Submission to mixed Use Development 26-30 Campsie Street & 1 Assets Street, Campsie Pre-lodgement (SSD- 99727456)

**Canterbury-Bankstown Council Submission
23 July 2026**

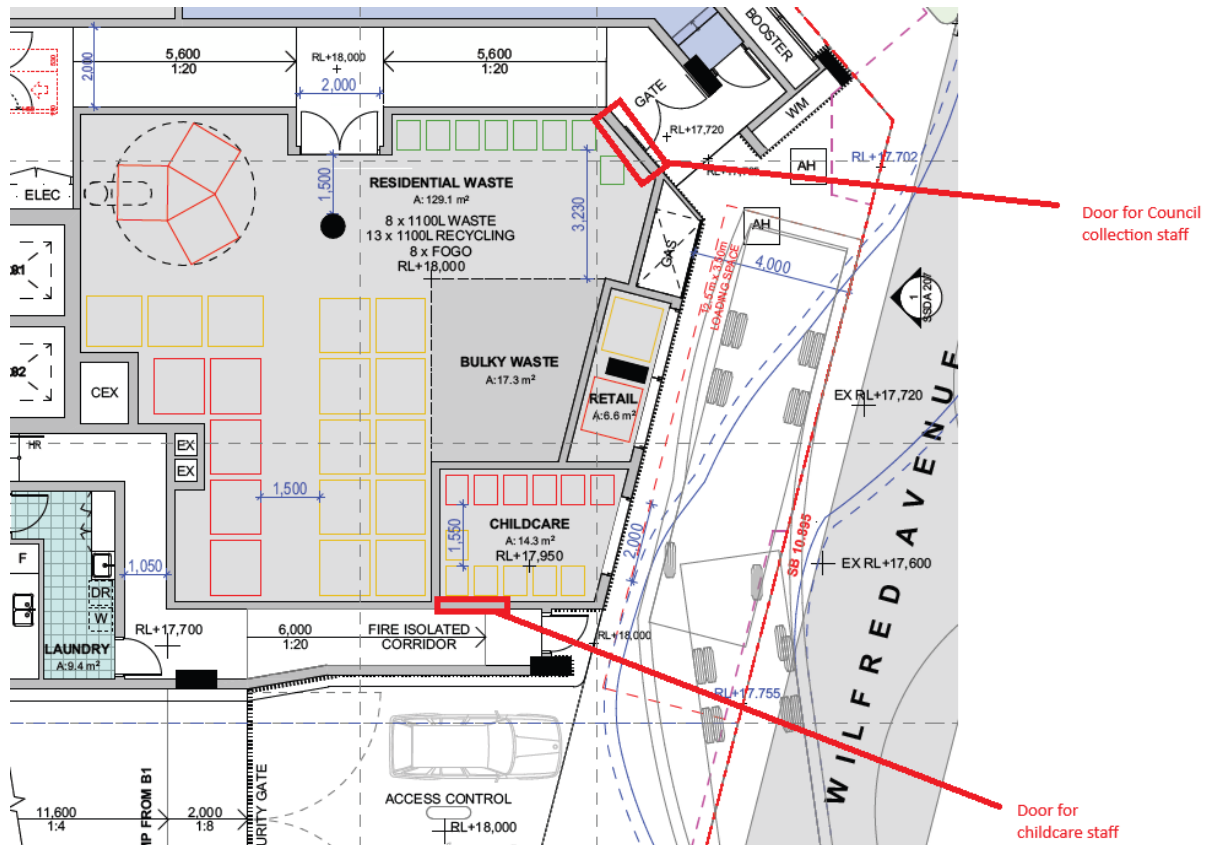
Safety concerns about location for waste collection location being located next to basement car parking access. Swept paths show the waste collection vehicles need to drive in front of and block the basement access driveway in order to enter and exit. There appears to be limited visibility between heavy vehicle drivers and drivers at the access driveway.

The exit swept path for the waste collection vehicles shows that it will need to occupy the full width of the lane, however vehicles are parked on the northern side of Wilfred Avenue.

Wilfred Avenue will not be able to accommodate parked vehicles and through movements of waste collection vehicles. Council will not be making any changes to the parking arrangements along Wilfred Avenue.

- Review and revise the proposed waste collection area to address the following issues:
 - Safety issues between heavy vehicle drivers and drivers at the access driveway.
 - Vehicles need to drive in front of and block the basement access driveway in order to enter and exit.
 - Limited visibility between heavy vehicle drivers and drivers at the access driveway
 - Access when vehicles are parking along Wilfred Lane.
- Relocate the waste collection door closer to the kerb, as shown in the below sketch above to meet Council's bin carting route requirements.
